# **City of Portland**

*Staff Presentation to the  
Portland Design Commission*

**2<sup>nd</sup> Design Advice Request**

**1417 NW 20<sup>th</sup> Avenue**

# Proposed & Previously Proposed Footprints

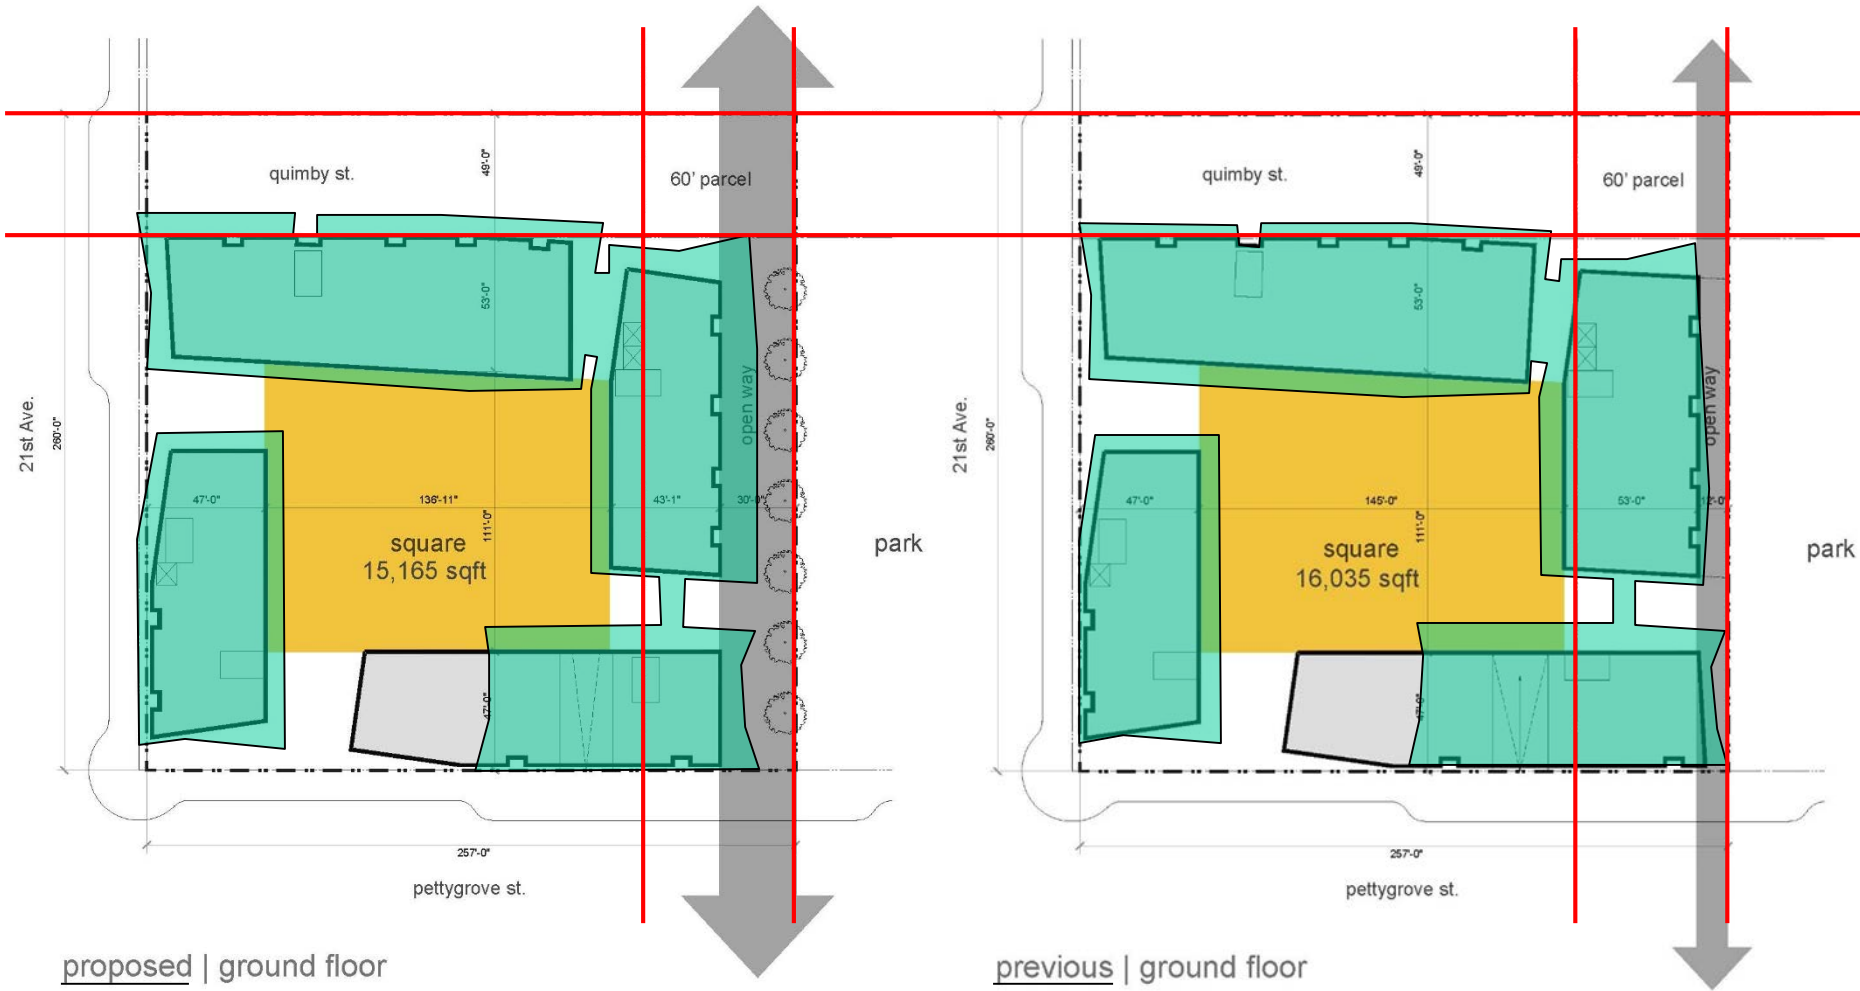
***The previous version showed the building extending 60' into the western portion of the Park; the current version extends 30' with a 12' overhang.***

***Is this enough to ensure connectivity and plentiful open space?***

# Quimby

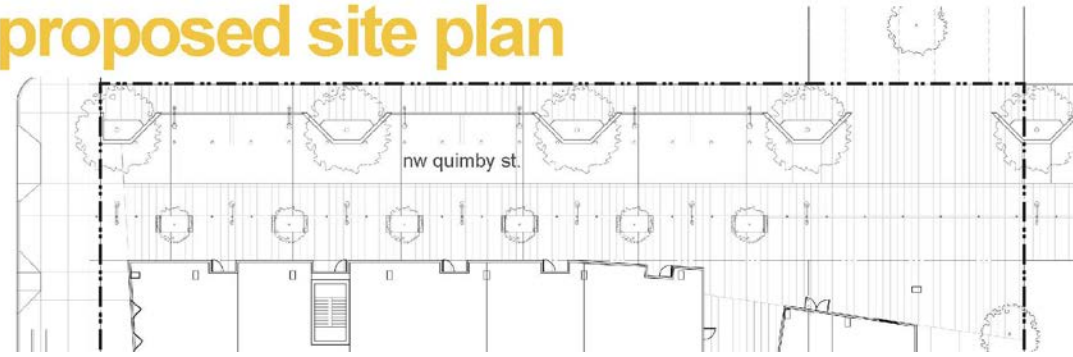
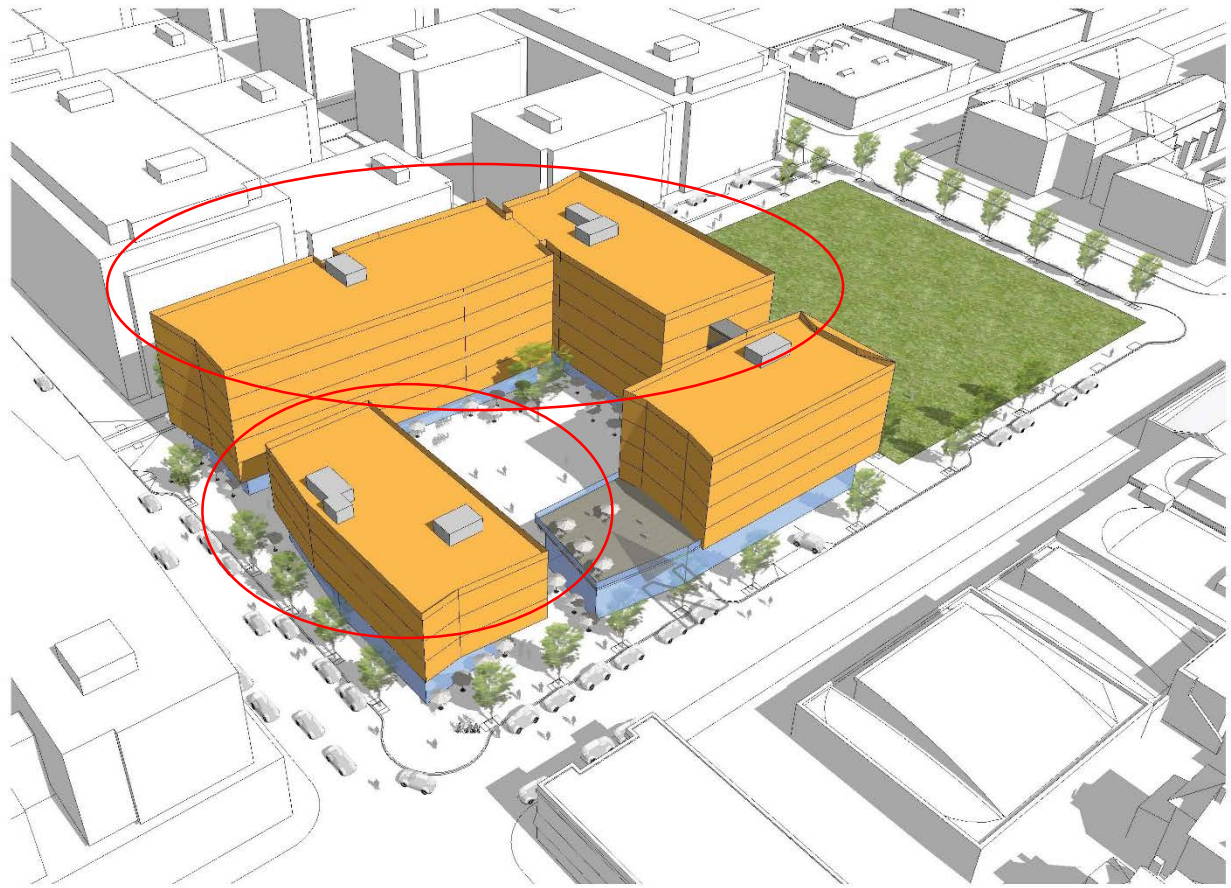
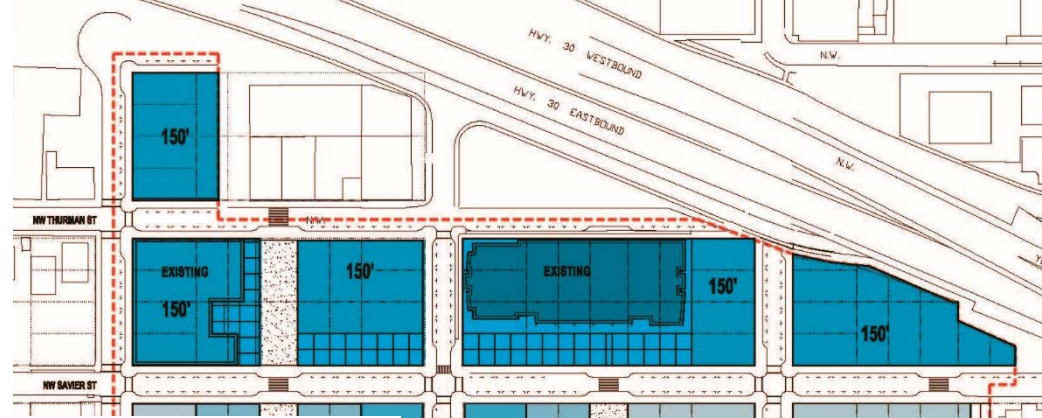
***The proposal still shows the building to encroach into the Quimby festival street, which is envisioned in the Master Plan primarily for bicycle and pedestrian use.***

***Quimby cannot be closed down for festival use if it is also used to access the garage.***

***Staff requested additional information on views and design concepts for Quimby.***

# Public Square

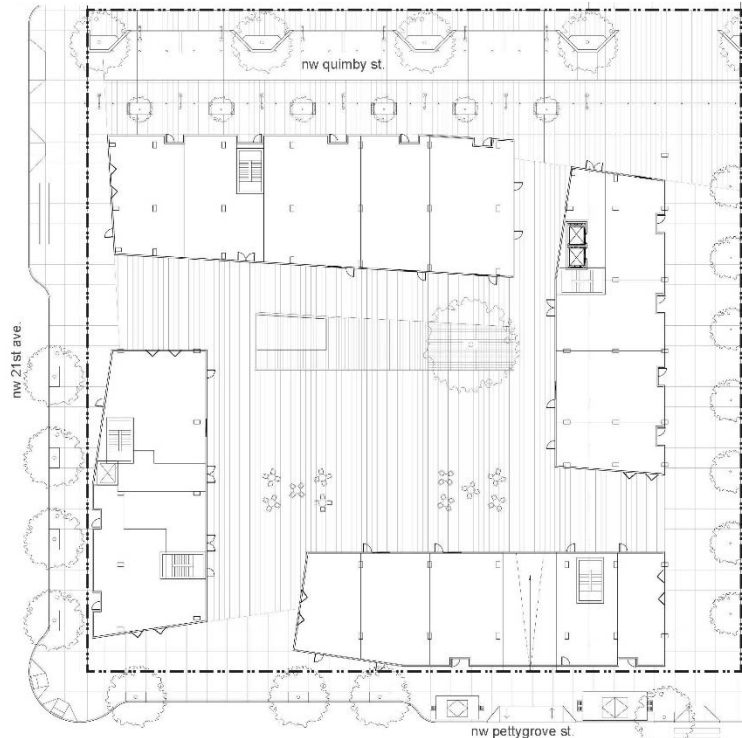
***Solar Studies provided show minimal difference between proposed heights and a 6-5-4-3 model***
